NORTHERN BEACHES LOCAL PLANNING PANEL

WEDNESDAY 31 AUGUST 2022

ITEM 4.1	DA2022/0448 - 7 COOLEENA ROAD, ELANORA HEIGHTS - SUBDIVISION OF ONE LOT INTO TWO AND PARTIAL DEMOLITION OF EXISTING DWELLING.
AUTHORISING MANAGER	Adam Richardson
TRIM FILE REF	2022/513641
ATTACHMENTS	1 ↓ Assessment Report 2 ↓ Site Plans

DEVELOPMENT APPLICATION ASSESSMENT REPORT

Figure 1: Location of the proposed indicative dwelling on Lot 2 as viewed from a ground floor bedroom of No.5 Cooleena Road

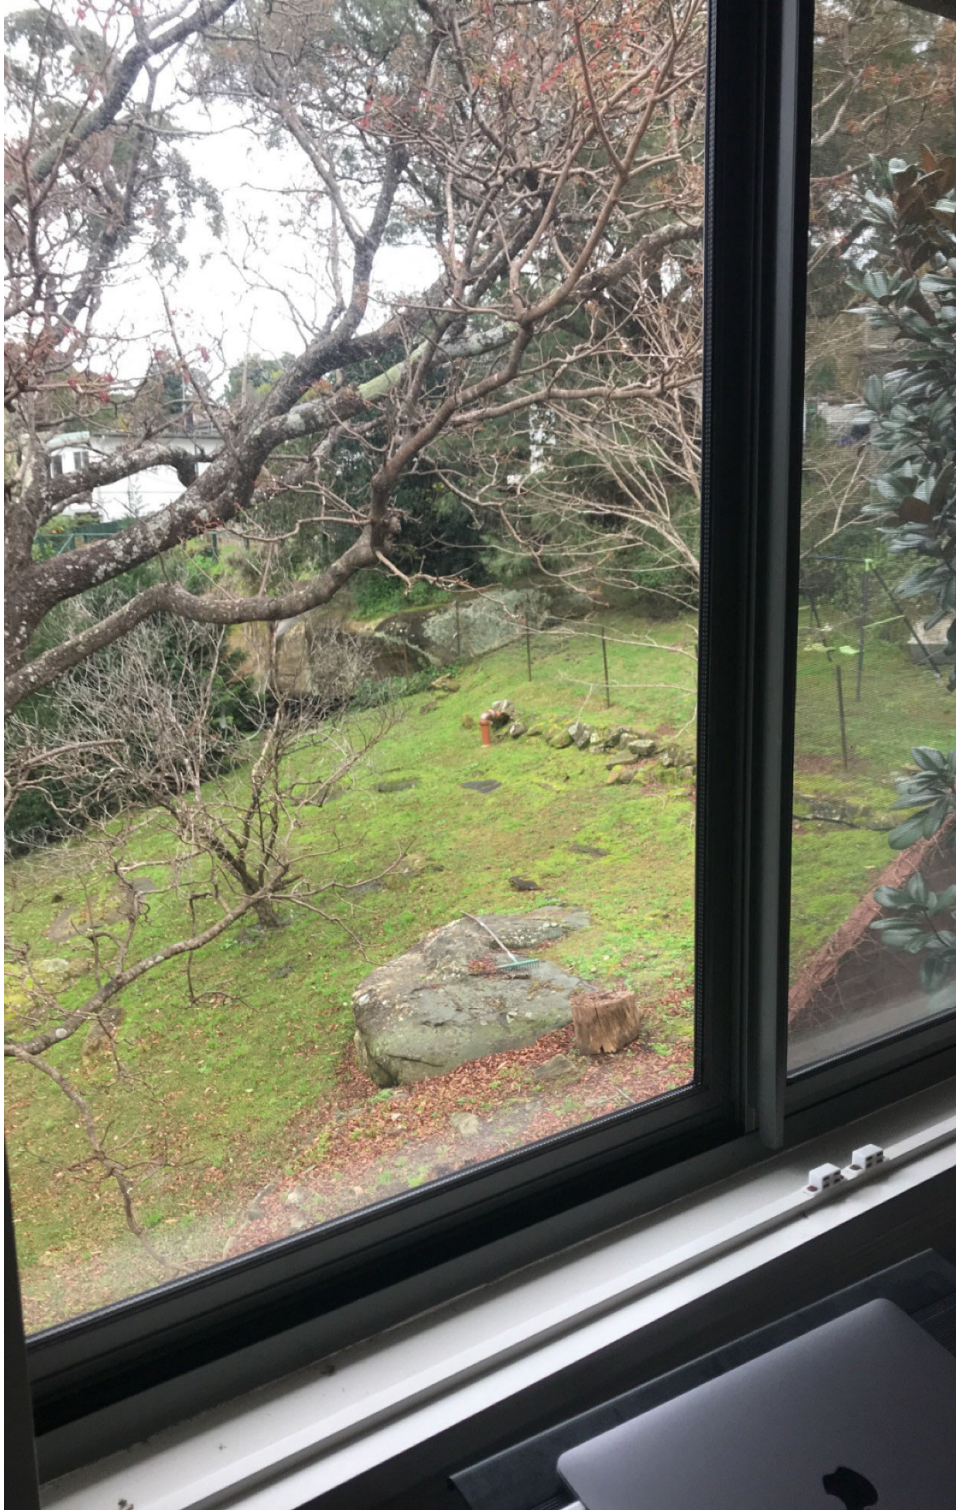
View loss concerns were raised by the adjoining property owners to the east (No.5 and No.5A Cooleena Road) and as a result, a site inspection was undertaken. Following the inspection, the affected views related to areas of vegetation and open space only. It was considered that the perceived loss of views related more specifically to the loss of a feeling of openness resulting from the location of the indicative dwelling on Lot 2, rather than a loss of any valuable iconic or water views. A full view loss assessment under the principals of *Tenacity Consulting v Waringah* [2004] NSWLEC 140 is therefore not considered necessary.

Building envelope breach south-east elevation (source Mathieson)

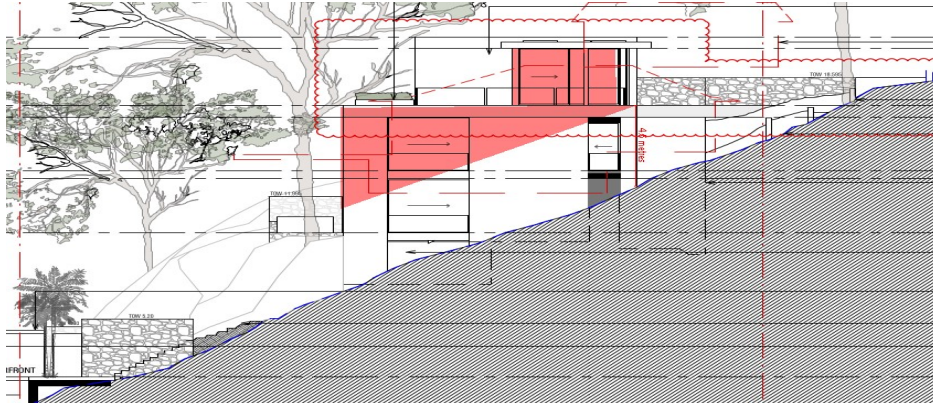
Level 1 - 5.6m (height) and 10.0m (width) and
level 2 - 3.1m (height) and 3.8m (width), refer to image below.

Building envelope breach north-west elevation (source Mathieson)

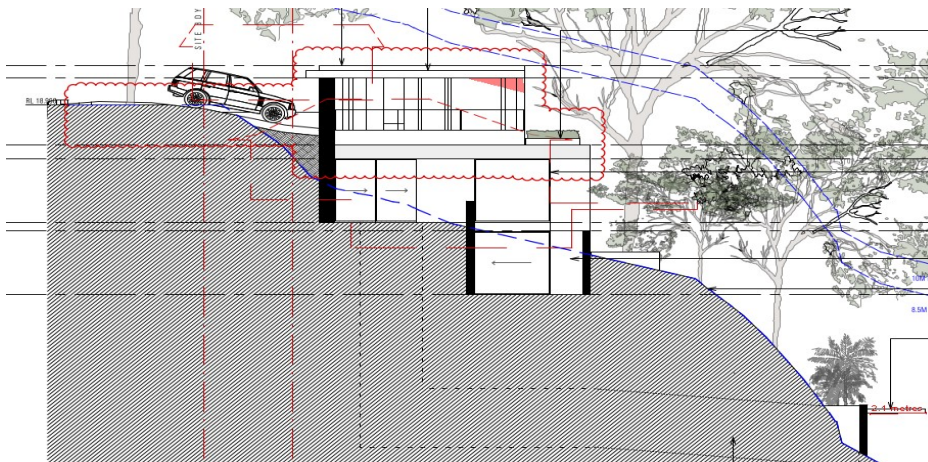
A small triangular corner of the Level 2 carport measuring 0.8m (height) and 2.0m (length).

Figure 1 - Height blanket diagram showing minor building height breaching elements above the 8.5 metre height standard (show by red mesh)

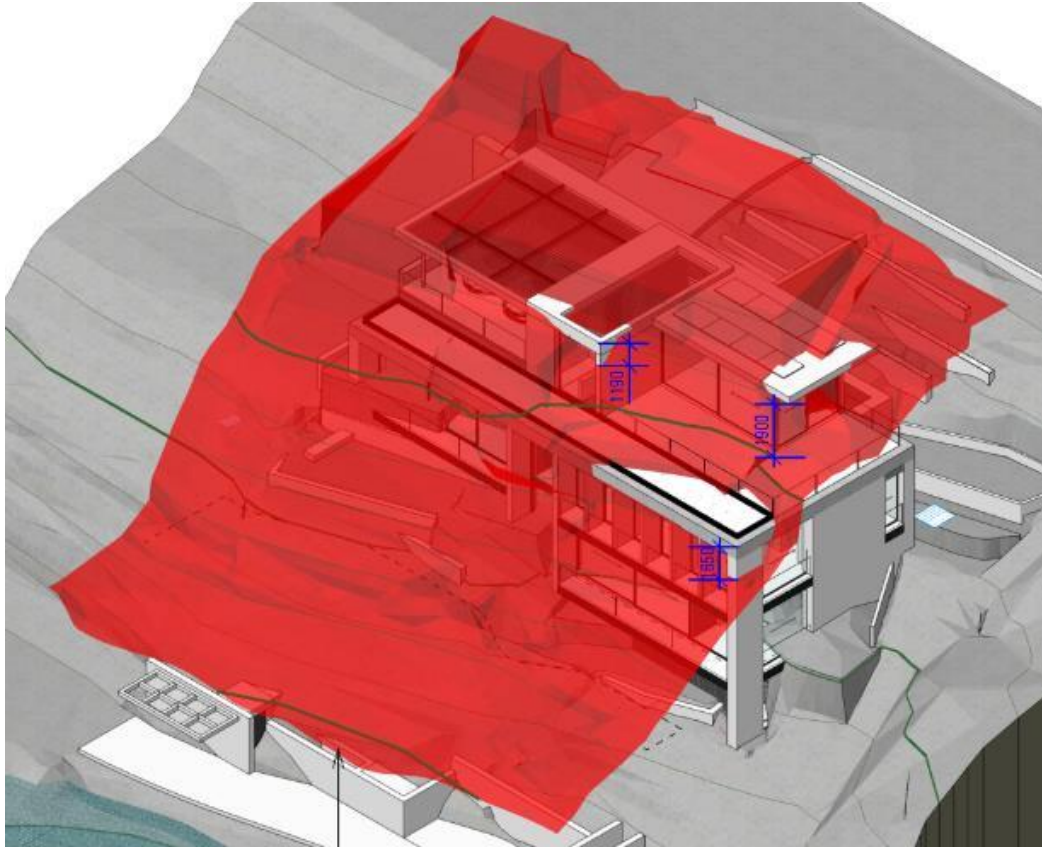
It has been determined that the south-western corner of the Level 2 entry staircase and roof over breach the height standard by a maximum of 1.190 metres (14%) with the deep eave at the southern end of the gymnasium at this level breaching the height standard by a maximum of 1.9 metres or 22.3%. Further, the roof form at the western edge of the level 1 Bedrooms 3 and 4 breach the height standard by a maximum of 1.65 metres or 19% with all building height breaching elements depicted in the building height blanket diagram at Figure 1 over page.

Figure 4 – Plan extract depicting the developments compliance with the 10 metre concessional building height blanket (in purple) with the building height blanket depicting the interpolated undisturbed levels of the land.

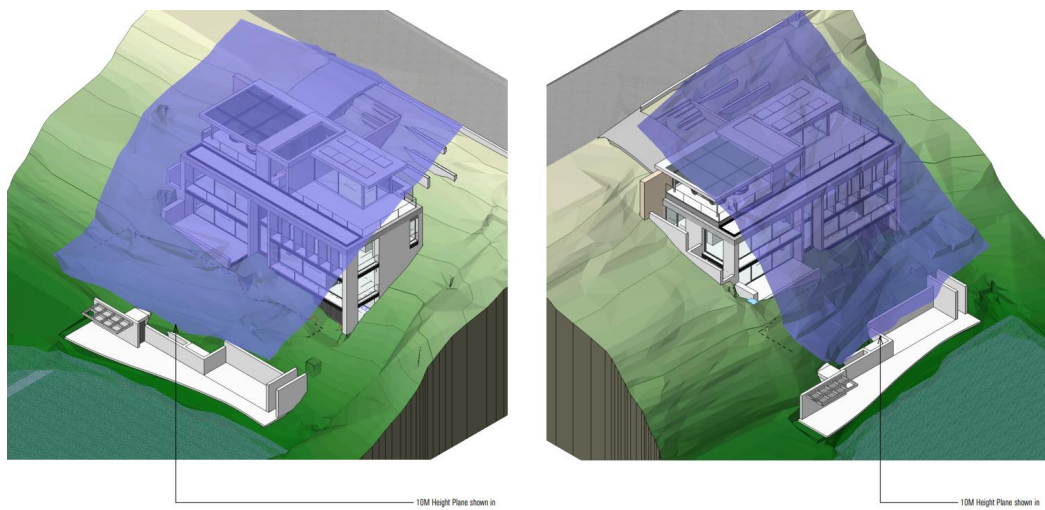
In this regard, I note that the prior excavation of the site within the footprint of the existing building distorts the height of buildings development standard plane overlaid above the site when compared to the natural undisturbed topography of the land. When the original undisturbed levels of the site are interpolated across the building footprint the proposed development would comply with the 10 metre concessional height standard at clause 4.3(2D) of PLEP 2014 is depicted in Figure 4 below.

Figure 1 - Plan extract showing the proposed building outline relative to the foreshore building line shown in red

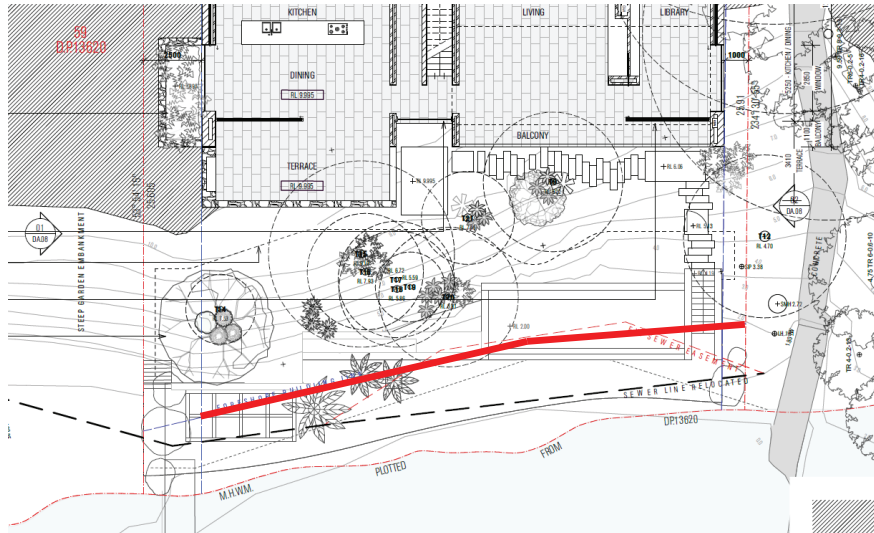
It has been determined that the proposed swimming pool, lightweight timber decking and associated pergola structures are located partially within the foreshore building line as depicted in Figure 1 below. I note that the proposed terrace area is located generally over the alignment of the existing hard paved area adjacent to the waterway as depicted in Figure 2.
